STAFF RECOMMENDATION
414 Greenway Avenue
March 20, 2013

Application: New construction—infill
District: Richland-West End Neighborhood Conservation Zoning Overlay
Council District: 24
Map and Parcel Number: 10405009200
Applicant: Randy Robinson, Robinson Construction
Project Lead: Melissa Baldock, melissa.baldock@nashville.gov

<p>Description of Project: Application is to construct a one-and-a-half story duplex and to renovate an existing secondary structure on the lot.</p> <p>Recommendation Summary: Staff recommends approval with the following conditions:</p> <ol style="list-style-type: none"> 1. Staff review and approve the asphalt shingle color, the materials for the front porch columns, floor and steps and the rear porch framing, and all window and door specifications prior to purchase and installation of these materials. 2. The HVAC and all utilities be located at the rear of the duplex or on the side, beyond the mid-point of the house 3. Staff approve all appurtenances not called out on the plans. <p>With these conditions, staff finds that the project meets Section II.B.1. of the <i>Richland-West End Addition Neighborhood Conservation Zoning Overlay: Handbook and Design Guide

Site Plan

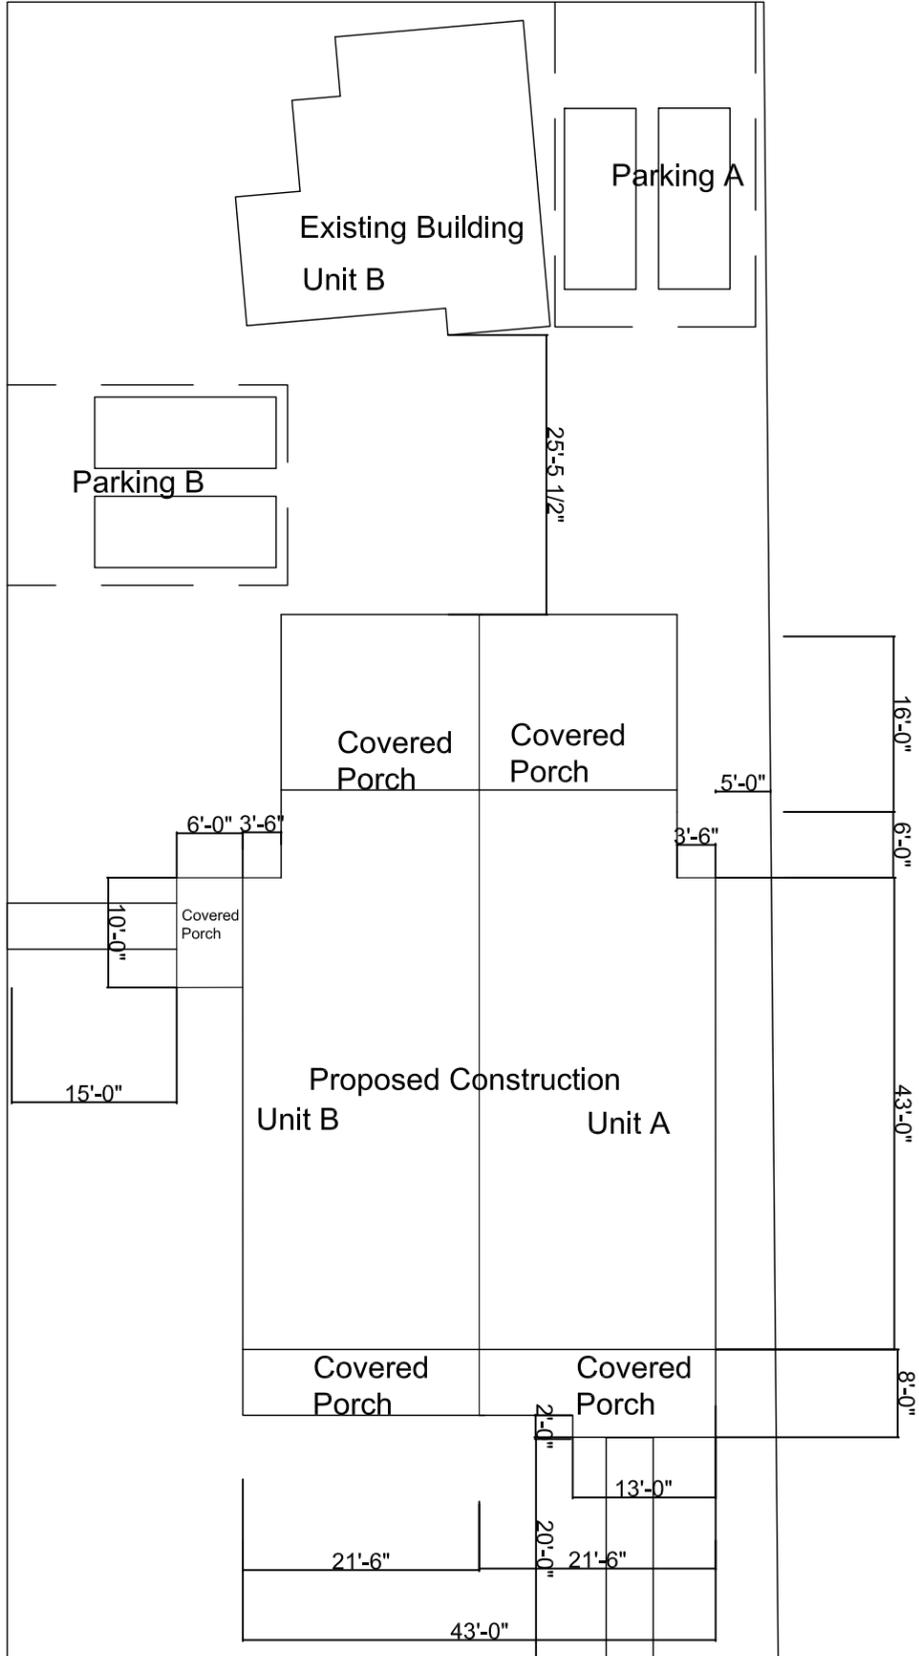
Appurtenances: The site plans shows two parking pads for two cars each (or four cars total). A parking pad will be created off the alley, in the rear of the property, which is appropriate. A second parking pad is proposed to be accessed from Hillsdale Avenue, towards the back of the lot but not near the alley. Although staff typically discourages access to parking via a side street when an alley is present, staff finds this parking pad to be appropriate in this instance because of the peculiarities of the site. The existing historic secondary structure prevents more parking from being situated off the alley, and pushing the parking further down Hillsdale Avenue towards the alley would mean parking in front of the historic secondary structure. The location of the parking off of Hillsdale is the most historically appropriate for this site. Ideally, the parking pad should be pushed off Hillsdale enough that the driveway could start as a single-lane; however, this scenario would not leave any yard for the proposed house of the existing structure. Staff finds the driveways to meet Section II.B.1.j. of the *Richland-West End Addition Neighborhood Conservation Zoning Overlay Handbook and Design Guidelines*.

No other appurtenances for the site were specified on the site plan. Staff asks to review and approve all additional appurtenances.

1. Staff review and approve the asphalt shingle color, the materials for the front porch floor and steps and the rear porch framing, and all window and door specifications prior to purchase and installation of these materials.
2. The HVAC and all utilities be located at the rear of the duplex or on the side, beyond the mid-point of the house
3. Staff approve all appurtenances not called out on the plans.

Front Elevation

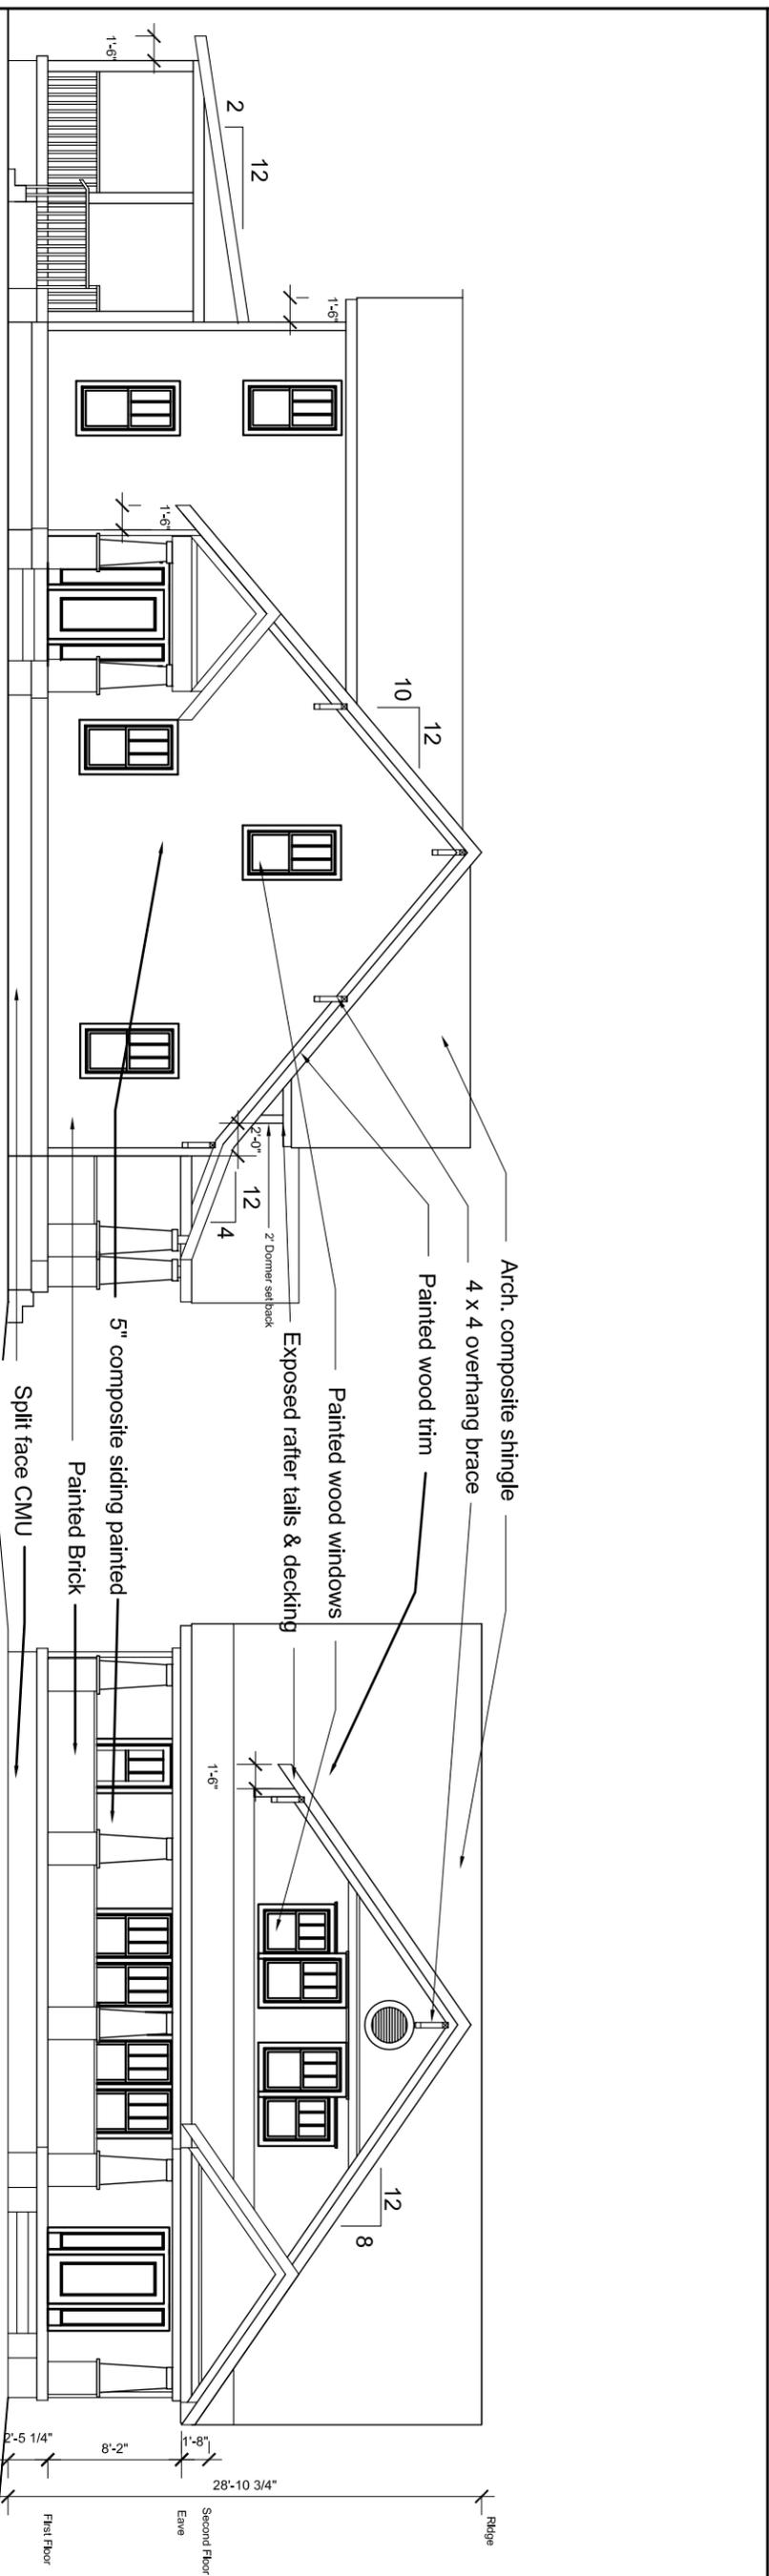
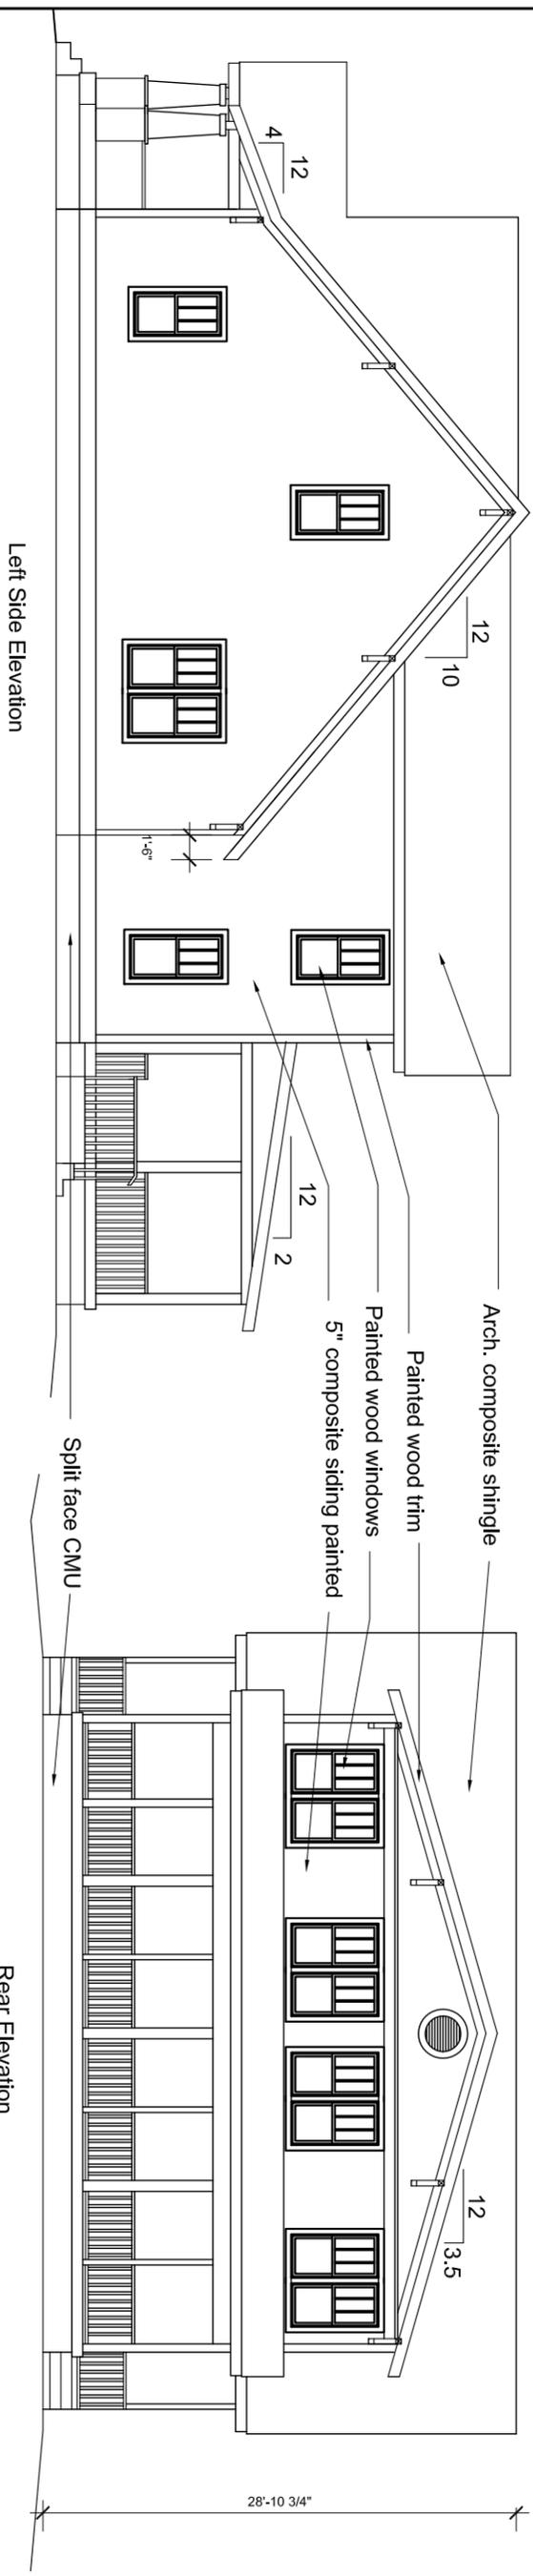
Height & Scale: The proposed duplex will be one-and-a-half stories tall and twenty-eight feet, eleven inches (28'11") from grade. The foundation will be approximately two feet, five inches (2'5") tall, and the eave height and porch height will be approximately thirteen feet, eight inches (13'8") above grade. The duplex will be forty-three feet (43') wide and seventy-three feet (73') deep, which includes a sixteen feet (16') deep rear covered porch. By comparison, the historic houses on Greenway are primarily one and one-and-a-half stories in height and range from twenty to twenty-seven feet (20'-27') tall. Along Murphy Avenue in this district, the historic houses are a little taller, going up to thirty-feet (30'). The widths of the historic houses on Greenway range from approximately thirty-two feet to forty-five feet (32'-45'), and their depths range from as little as thirty-one feet to as much as eighty feet (31'-80'). Staff finds the height and scale of the proposed primary structure to be in keeping with that of the historic context along Greenway Avenue. Staff finds that the height and scale of the proposed infill meets Sections II.B.1. a. and II.B.1.b. of the *Richland-West End Addition Neighborhood Conservation Zoning Overlay Handbook and Design Guidelines*.

Materials: The duplex's primary cladding material will be smooth-face cement fiberboard with a five inch (5") reveal. The trim will be wood. The house's foundation will be split face concrete block, and the porch wall and column bases will be painted brick. The materials for the column shafts were not specified. The roof will be architectural composite shingle, and staff asks to review the shingle color prior to purchase and installation. The windows will be wood, and the door material was not specified. Staff asks to review all window and door materials and specifications prior to purchase and installation. The materials for the front porch floor and steps, and the rear porch were not specified, and staff asks to review these materials as a condition of approval. With the above-mentioned staff reviews, staff finds that the materials for the primary structure meet Section II.B.1. d. of the *Richland-West End Addition Neighborhood Conservation Zoning Overlay Handbook and Design Guidelines*.

Roof: The duplex's primary roof form will be a side gable with a slope of 10/12. The front facade has a gabled dormer with a slope of 8/12. The front porch roof will be a shed roof with a slope of 4/12, and rear porch roof will be a 2/12 shed. The rear facade has a gabled dormer with a slope of 3.5/12. Staff finds the primary structure's roof forms to meet Section II.B.1.e. of the *Richland-West End Addition Neighborhood Conservation Zoning Overlay Handbook and Design Guidelines*.

Orientation: The proposed duplex is designed to face Greenway Avenue, which is appropriate. The structure has a full width-front porch. The structure will read as a single-family house from Greenway Avenue. The entrance to the right unit has a pedimented entryway which will read as the primary entrance for the structure. The entrance to the left unit on the front facade will read as a window from the street because of an enclosed railing. A pedimented entryway to the left unit is located on the left facade, facing Hillsdale Avenue. Staff finds the orientation of the duplex to meet Section II.B.1.f of the *Richland-West End Addition Neighborhood Conservation Zoning Overlay Handbook and Design Guidelines*.

Proportion and Rhythm of Openings: The primary windows on the infill are approximately twice as tall as they are wide, and so meet the historic ratio of windows. The right and the left facades contain wall space of nineteen feet (19') and sixteen feet (16'), respectively, without a window or door opening. Staff finds these expanses to be appropriate because they occur beyond the front part of the house. Staff therefore finds that the window proportions and rhythm of openings meets Section II.B.1.g. of the *Richland-West End Addition Neighborhood Conservation Zoning Overlay Handbook and Design Guidelines*.
